Evaluation Report 650

Case IH 4900 Vibra Chisel

CASE IH 4900 VIBRA CHISEL

FIGURE 3. Sweep Pitch for the Case IH 4900 Vibra Chisel Shank.

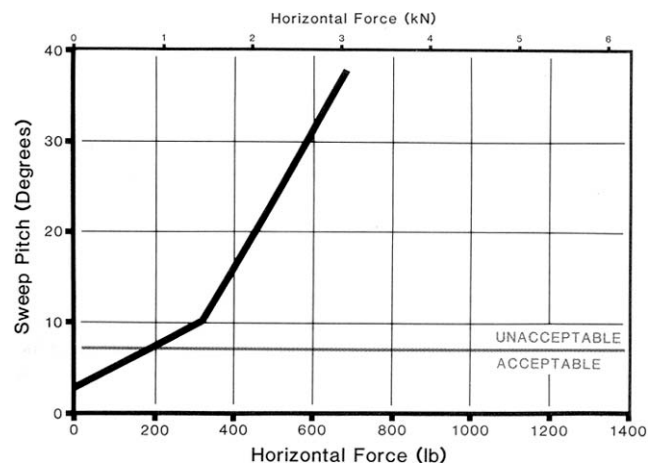
The no-load sweep pitch was 3°. FIGURE 3 shows that as force is applied to the sweep, the pitch increases due to shank flexing (lower sloped line). At a horizontal force of 305 lb (1.4 kN), the shank begins to trip as the spring preload is overcome. This is the point on the graph when the steep upper curve begins.

The soil forces encountered by sweeps and other soil tools on the front row of a cultivator operating in typical prairie conditions are given in APPENDIX II. This chart shows that although the sweep pitch will be relatively high, the shank assemblies would not trip in most secondary and light primary tillage. The sweep pitch when operating in secondary or light primary tillage conditions would usually exceed the recommended angle of 7° from shank flexing. These characteristics were confirmed in the field. In light primary tillage, the furrow bottom ridges (FIGURE 4) were 3/4 in (19 mm) high although no weed misses occurred. It is recommended that the manufacturer consider providing shanks that flex less under load to maintain a lower sweep pitch angle.

1. The Vibra Shanks and Vibra Chisel are for light primary and secondary tillage. Heavier shanks are available on the Case IH chisel plows. Also, Case IH has recently introduced a lower pitch cultivator sweep line.

FIGURE 5. Shank Mechanism.

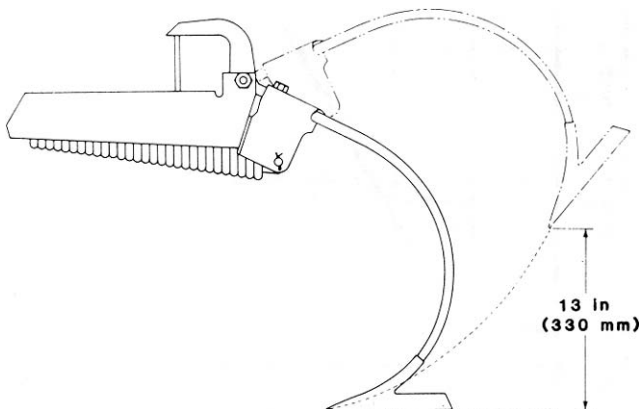
The maximum lift height of the Case IH 4900 cultivator shanks was 13 in (330 mm), when equipped with the 14 in (350 mm) sweeps (FIGURE 5). This trip height would normally prevent shank and sweep damage in fields with many large rocks. However, at several locations, the sweep wings would hit the cultivator frame while lifting over rocks. Also, one tire was punctured by a sweep that was forced sideways while clearing a

rock. It is recommended that the manufacturer modify the sweep pattern to improve frame and wheel clearance for the shanks.

8. Case IH is currently reviewing the sweep pattern to improve wheel clearance for the shanks.

FIGURE 8. Sweep Pattern.

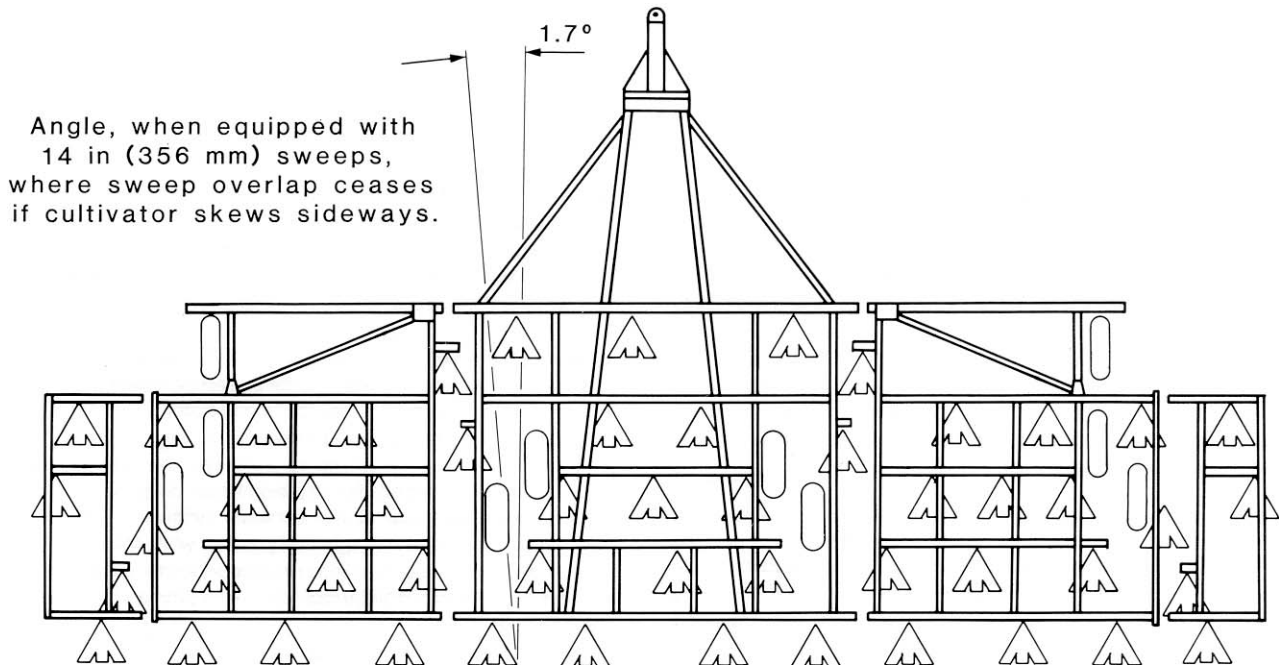
Skewing and Stability: The Case IH 4900 was stable and did not skew in typical field conditions. The sweep pattern of the Case IH 4900 (FIGURE 8) was symmetric and did not impose side forces on the cultivator when operated on level ground. Skewing did occur on steep hillsides or where soil hardness varied across the width of the machine. Like all cultivators, weed misses did occur on hillsides when the cultivator skewed. Care must be taken to work up and down the hillsides to ensure adequate weed kill.

A tire was deflated after it was hit by a sweep. The shank was forced sideways and upward when it was tripping over a rock. The shanks of the Case IH 4900 cultivator are very flexible and require a lot of clearance vertically and horizontally. It is recommended that the manufacturer consider modifying the sweep pattern to provide better clearance around the wheel locations and frame members.
